Re: Rapiscan AIT System Radiation Survey Reporting

**R-0646-1 Addendum
(Documentation Errors)**

Product Name	Secure 1000SP (Single Pose)
Serial Number	S51037006
Radiation Emission Measurement	Radiation Survey Dated: 11/02/2010
RSO Initials

1. In Beam Dose Measurement: Survey Table. 1

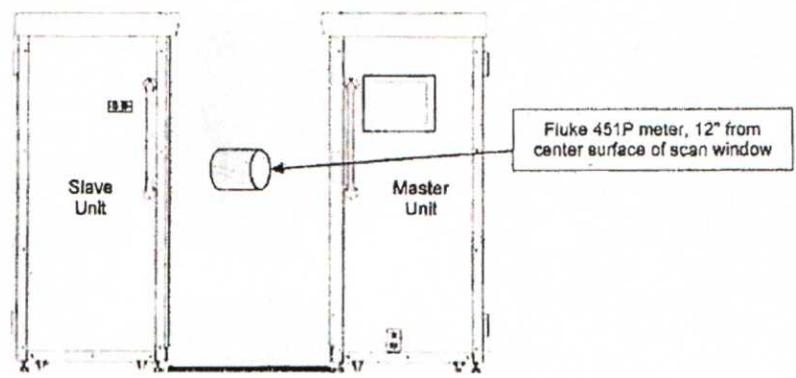
1. No value indicated for background radiation. Typical values range from 7uRem/hr to 13uRem/hr at sea level. Note: Absence of value has no adverse impact on calculations.
2. Values for operating parameters were left blank. Values should have read: 50kVp and 5mA.
3. TABLE 1: Incorrect presentation of data in Column 3 for Measured Exposure. Indicated values are 19uR and 15uR. Corrected values are 1.9uR and 1.5uR. The values were corrected by technician when calculating Effective Dose.
4. TABLE 1: No values in Column 6 for Effective Dose. Corrected values, per RSO calculations, are 1.09 uRem and .86 uRem.
5. Based on review of survey by RSO, RSO determined that Technician incorrectly marked the fail check box.

The service technician should attend refresher training.

The corrected data indicates this system was operating within expected parameters. No re-survey is required for this system.
